## **Planning Commission Staff Report**

**Subject:** Rezoning Issues Report

**Petition:** P.Z. 34-2007 Blue Ocean (Johnny Y Properties L.L.C.)

RE: **P.Z. 34-2007 Blue Ocean (Johnny Y Properties)**

# A PRELIMINARY DEVELOPMENT PLAN OF BLUE OCEAN

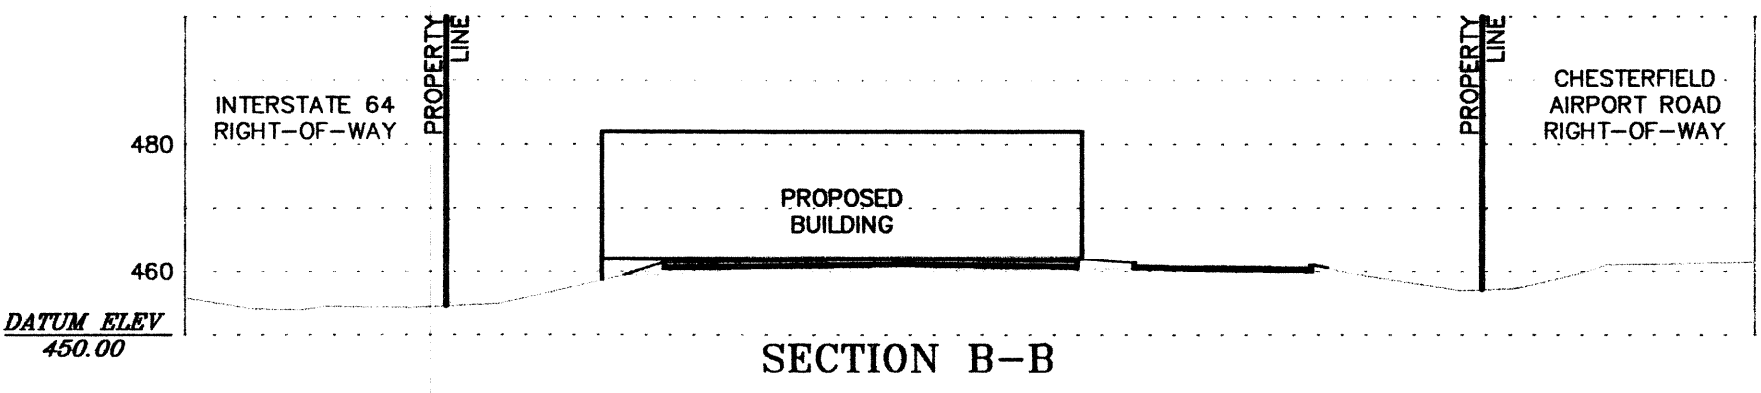
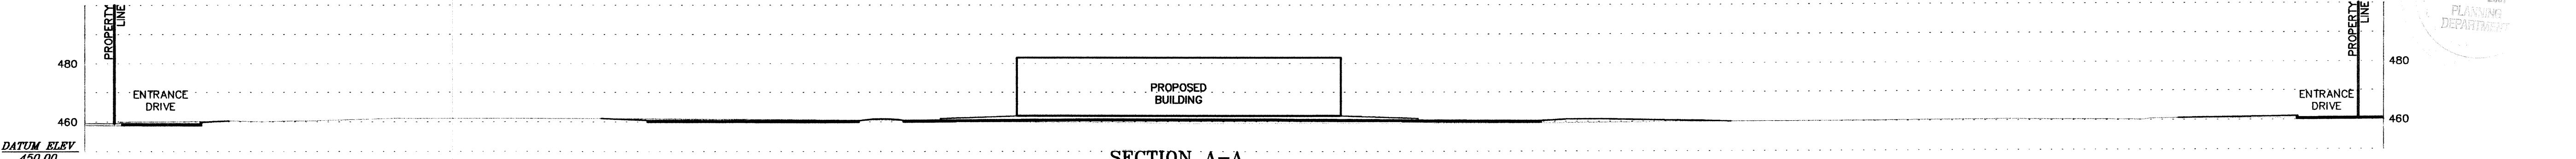
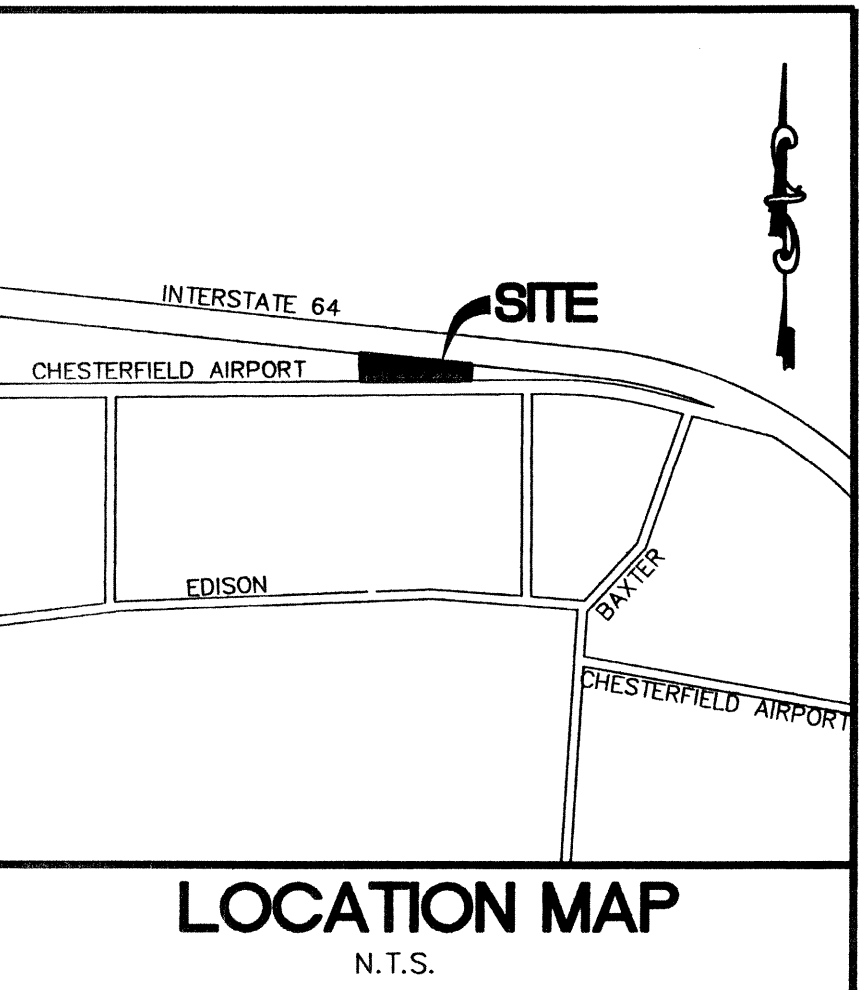
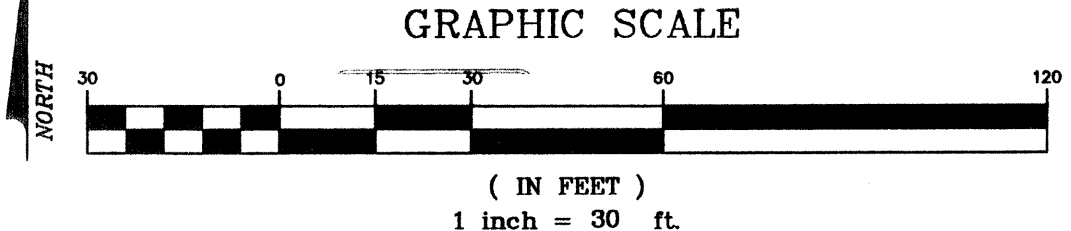
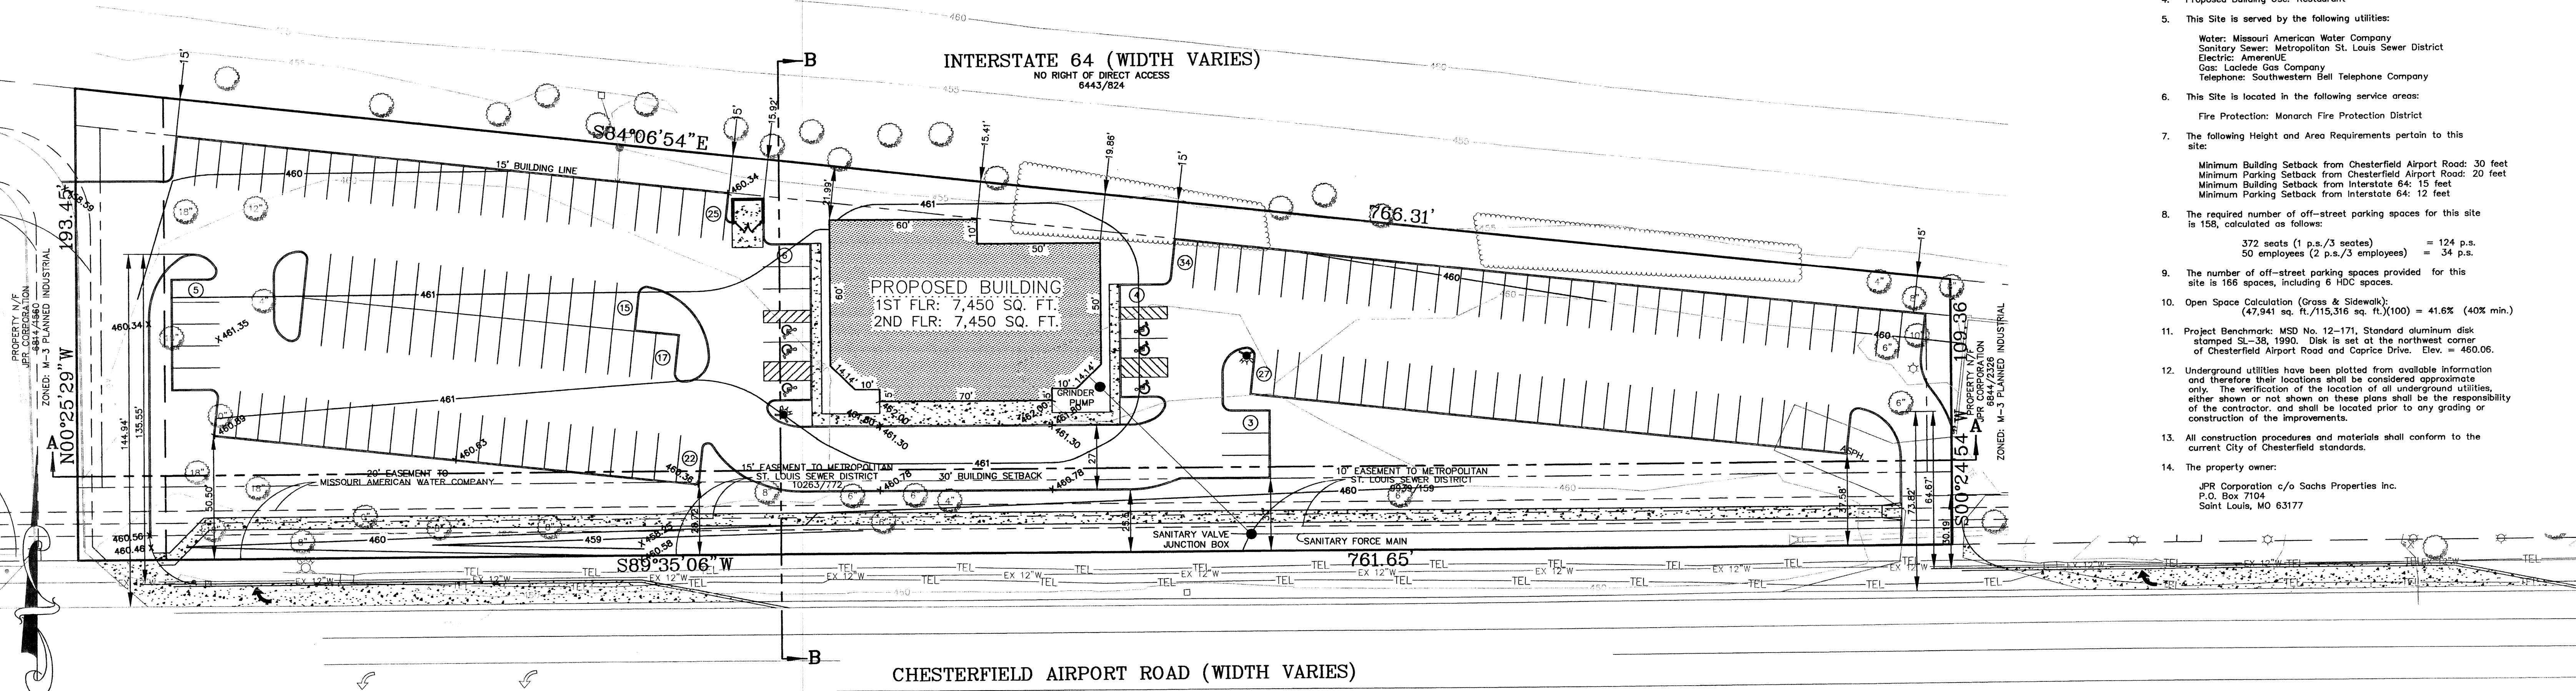
4. Provide on the preliminary plan the location of the right of way of Interstate 64 and where the pavement begins from the northern property line of the development. Petitioner is submitting an amended site plan which shows the location of the pavement area of US 40/64, which is 70 feet from the northern property line. There is a total of 53,642 square feet of non-pavement open space, already containing a number of high quality, mature trees that will not be removed, within the MoDOT right-of-way adjacent to the Northern Boundary.

5. How will pedestrian access from the Kemp Auto Museum be addressed? The amended site plan shows the location of the sidewalk and cross walks to provide for pedestrian access from the west.

6. There is concern regarding the vehicular and pedestrian circulation throughout the site. The amended site plan has been revised to provide for better pedestrian and vehicular circulation. The plan meets Monarch's preliminary comments as well as the City's requirements for access, turning radius and road widths.

8. There are three (3) parking spaces located to the south east of the building which may cause conflict with the circulation on the site. Currently the preliminary plan depicts 166 parking spaces and City of Chesterfield City Code requires 158. Petitioner believes the location and access to these existing parking stalls meets the City's requirements for such and at this time has 158 total and not 166 as incorrectly depicted on Petitioner's site plan.

9. Parking spaces on the east side of the site should not be situated so that cars will back into the entrance drive. Petitioner understands the location of these three stalls do not meet the City's requirements for location for the reasons indicated by Aimee Nassif. Petitioner intends on either eliminating or relocating these three stalls to an acceptable location and revising the site plan accordingly. Petitioner would like to consider the other issues that may be raised by the staff and Commission before submitting a revision on this issue.

10. The sidewalk should approach Chesterfield Airport Road at the entrances. Pedestrians should not be directed to a point behind stopped cars. The site plan provides for pedestrian crosswalks at the Airport Road entrances, as requested.
